**PLANNING COMMISSION
REPLAT AND SUBDIVISION PLAT**

AGENDA ITEM NO: 20 December 14, 2005

RENAISSANCE AT THE
DOMINION, UNIT 4
SUBDIVISION NAME

050089
PLAT #

HALLIE HEIGHTS SUBDIVISION SIDEWALK VARIANCE REQUEST

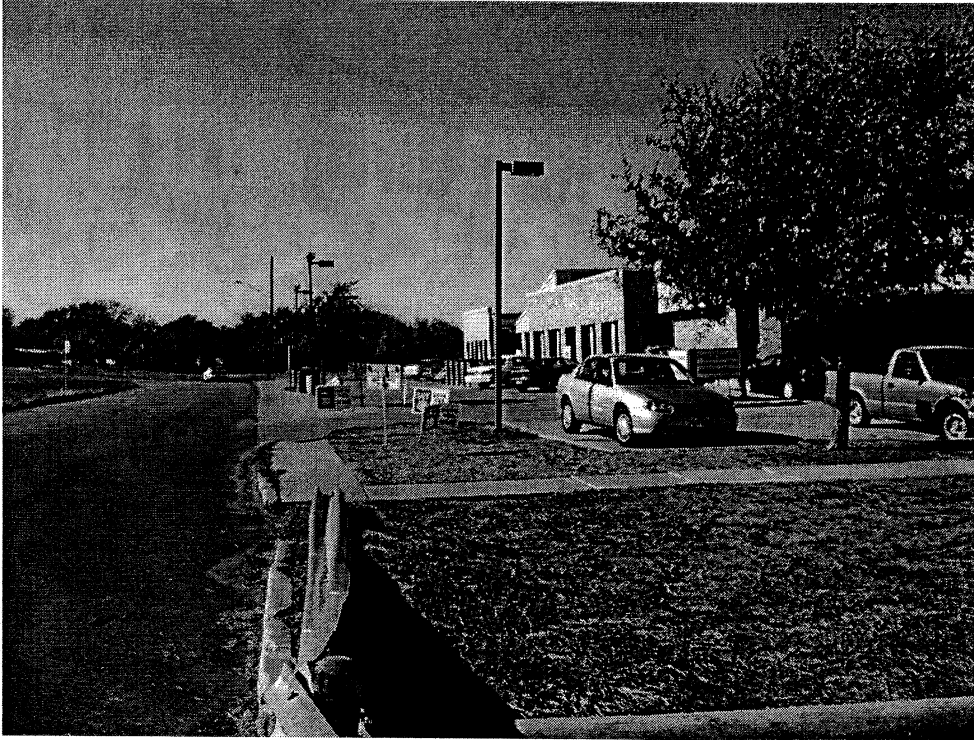
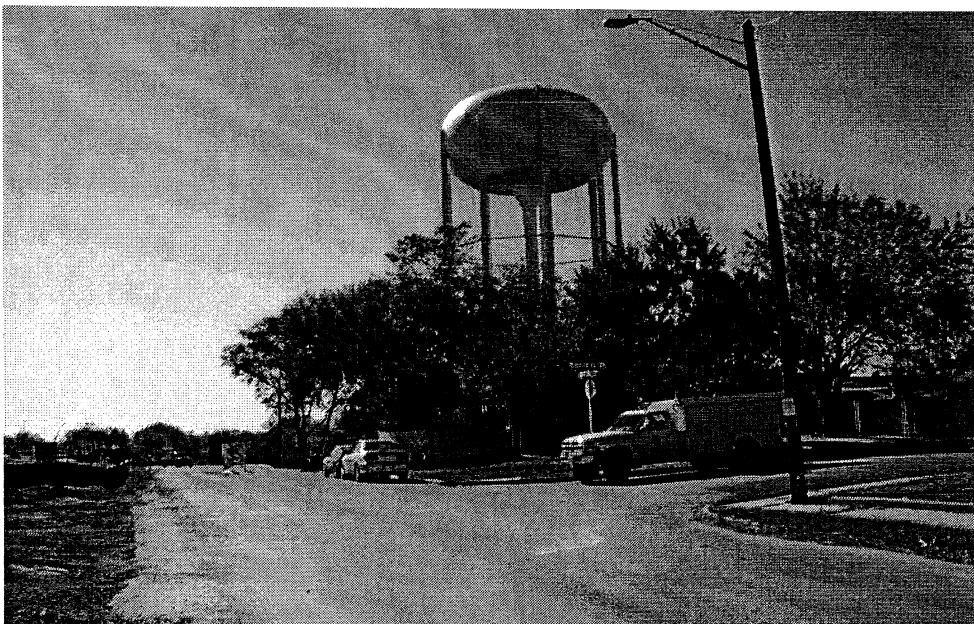
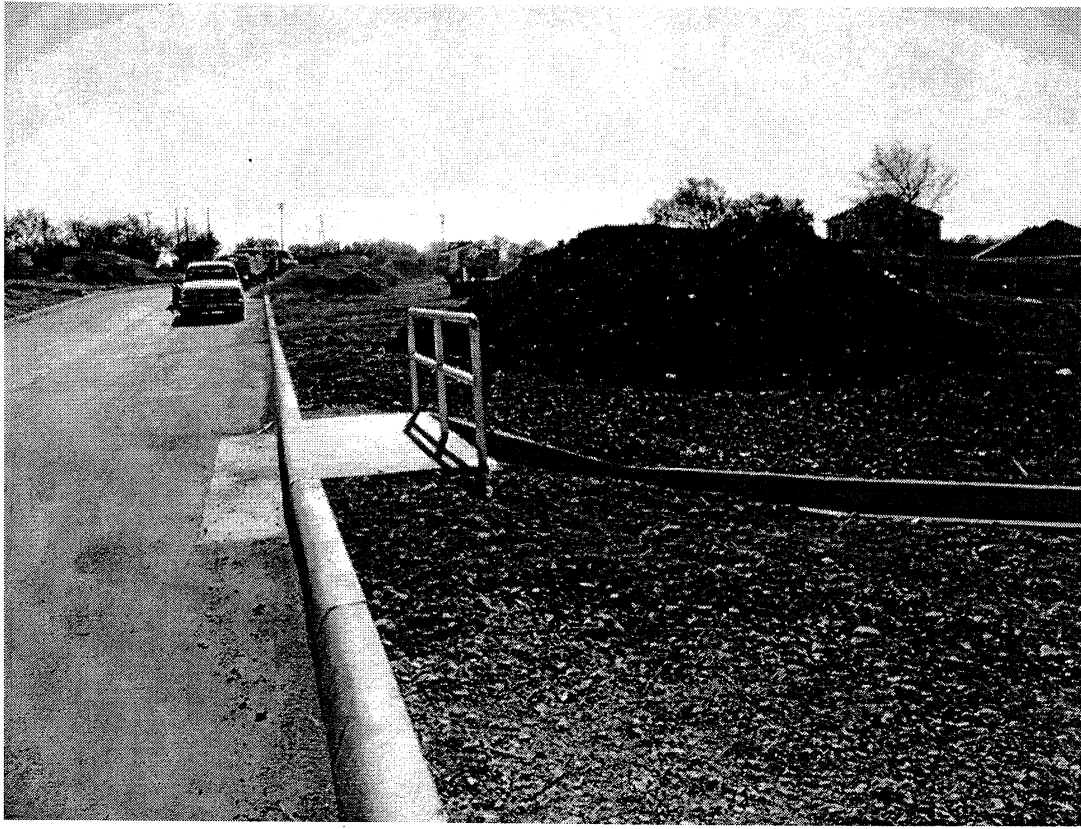
Johnston Branch Library is located @ the intersection of Sun Valley and Medina Base roads. A sidewalk runs along the site up Sun Valley rd. on both sides of the road until Meadow Valley, but continues on eastside of street. The sidewalk starts again on the west side at the Paradise Valley intersection. The limits of the approximately 200 ft. section subject to variance consideration is shown in the following two photographs.

FINDINGS AND RECOMMENDATIONS:

RECOMMENDATIONS:
